HORSHAM DISTRICT COUNCIL CONSULTATION

TO:	Horsham District Council – Planning Dept
LOCATION:	Land at The Crows Nest New Hall Lane Small Dole
DESCRIPTION:	Erection of a single chalet bungalow and detached garage
REFERENCE:	DC/26/1246
RECOMMENDATION:	Advice / Modification to Plot P7,1
SUMMARY OF COMMENTS & RECOMMENDATION: The application is supported by an Arboricultural Impact Assessment (AIA), Arboricultural Method Statement (AMS) and Tree Protection Plan (TPP) prepared by Lizard Landscape Design and Ecology. The submitted information advises that the proposed development has been designed to retain all Category A and Category B trees. Whilst the proposed removal of the identified Category C and Category U trees is not considered objectionable in arboricultural terms, clarification is required regarding T14, which appears to be located outside the application site boundary but is shown for removal. Concerns remain regarding the extent of development proposed within the Root Protection Area (RPA) of T29. Following site inspection and the collection of actual stem measurements, it is considered that the influence of T29 is greater than currently illustrated within the submitted docu

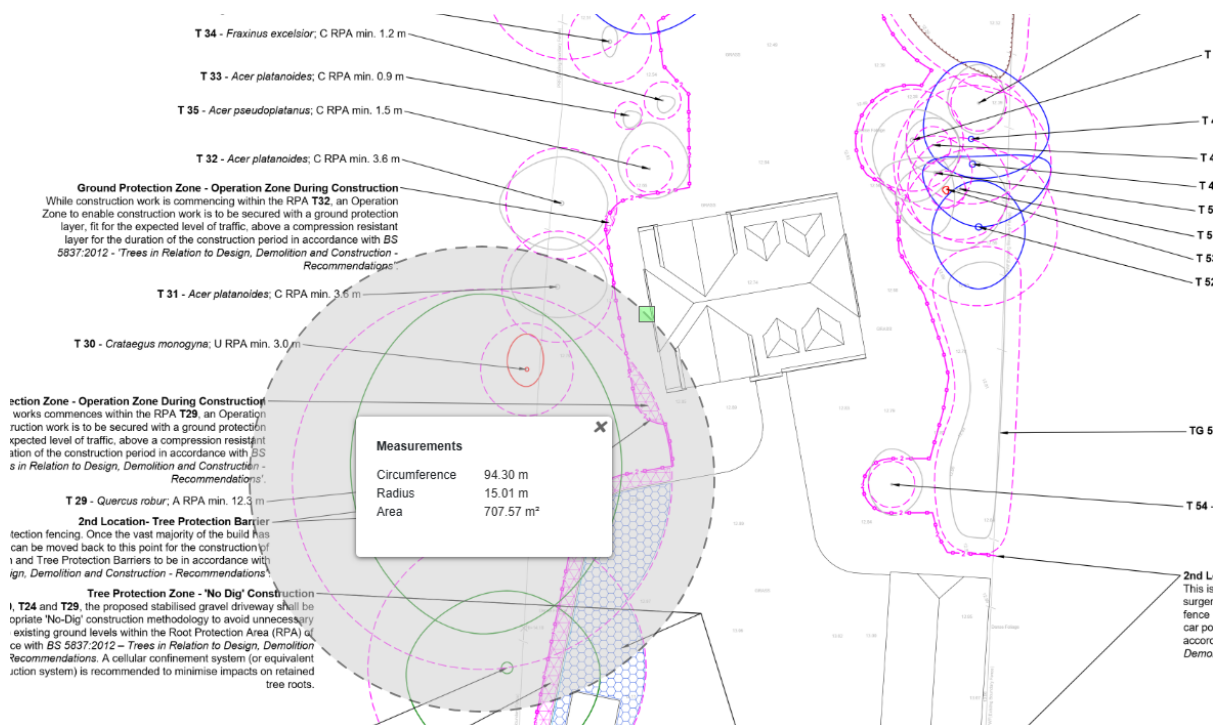
Whilst the report provides mitigation measures, it should be noted that incursions into the RPAs of retained trees, particularly Category A trees T19, T24 and T29, require clear and robust justification in accordance with BS5837 principles. In this instance, the proposed no-dig construction and temporary ground protection measures appear intended to provide that justification; however, the successful retention of these trees will be dependent upon the construction methodology being implemented in full and appropriately supervised throughout the development process.

It is noted that the survey schedule records the stem diameters of T24 and T29 as estimated measurements due to access constraints associated with the trees being located outside the site. During my site visit, actual stem measurements were obtained. T24 was measured at 630mm DBH. Due to the pronounced buttressing exhibited by T29, it was not possible to obtain a measurement at 1.5m above ground level; however, a stem diameter of 1,870mm was recorded at 1.3m AGL. The submitted RPA calculations are based upon estimated measurements and therefore do not appear to accurately reflect the degree of influence exerted by T29 on the development proposals.

T29 is of considerable arboricultural and landscape value. However, its RPA should be capped at the maximum 15m radius as prescribed by BS5837:2012.
